October 13, 2016

**RE: Painted Hills PRD Floodplain/CLOMR Submittal Review #1 from Spokane County  
Response to Comments**

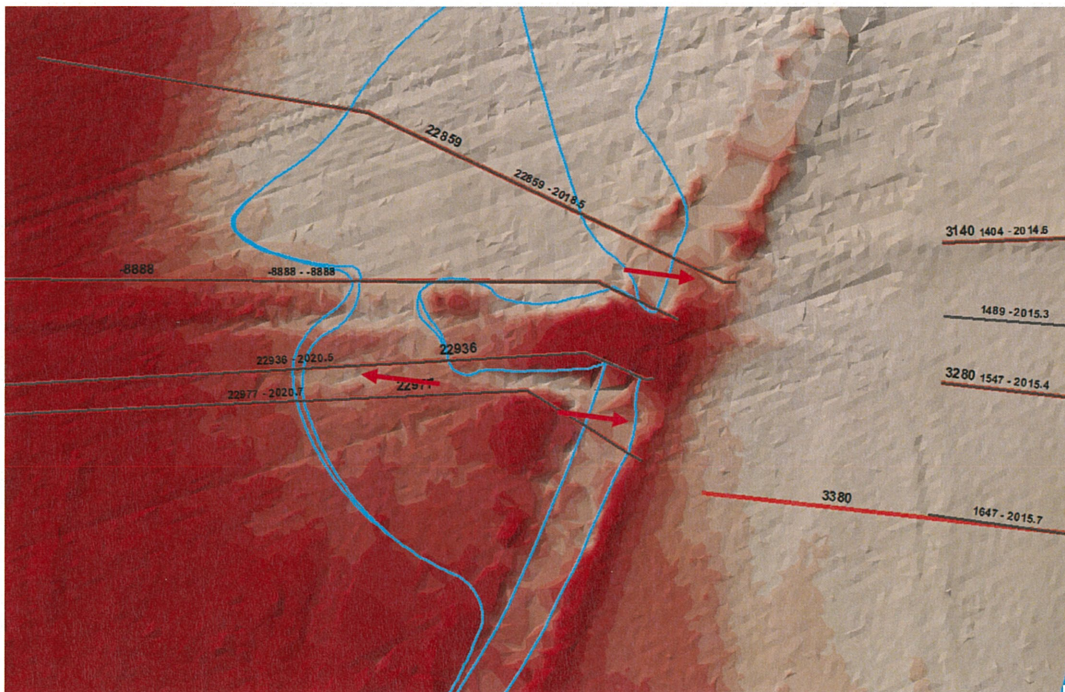
5. Page 5 – Consider the previously un-mapped/un-modeled overflow of Chester Creek into the golf course overflow reach about 3000 feet south of Thorpe Road. This may increase the 100-year flow in the golf course overflow reach.

***The flow split 3,000 feet south of Thorpe Road is the overflow point that is the origin of the golf course overflow path which is already accounted for in the FEMA models and CLOMR materials. Due to this, we requested clarification on the comment from Marianne Barrentine. She indicated that the comment is referring to an observed but unmapped flow split which occurs at the private driveway approximately 1,500 feet downstream of Thorpe Road. Marianne provided a series of photos that show some overtopping which had occurred in March of 2012. The photos show water leaving the main channel upstream of the culvert and flowing both east and west. One photo also shows what appears to be water splitting to the east from just downstream of the culvert. The western split is both mapped and modeled in the effective FIS but the eastern splits are not. WCE visited the site in order to provide WEST a summary of current observations. During the visit they also spoke with the property owner. Based on LiDAR data and site observations, the mapped western flow split appears to be the major flow path north of the culvert.***

***Based on LiDAR data, the approximate low point in the right bank is 2021.4 ft. This is higher than the 0.2% annual chance flood based on the effective FIS model at XS 23051 (US face of culvert). It should be noted that due to riparian vegetation, the LiDAR data could be providing elevations that are too high. For comparative purposes, the effective model was modified to provide more resolution at the culvert. The left overbanks of the four cross sections used to***

***model the culvert opening (23090 through 22972) were converted to ineffective flow and the low spots to the east and west of the culvert were converted to lateral structures and set to optimize in RAS. This is a more complex and detailed method of approximating the two-dimensional flow conditions present at the site within the confines of a one-dimensional model. Even with the changes, the model only indicated overtopping along the western flow path and no overtopping is shown along the eastern flow path either upstream or downstream of the culvert.***
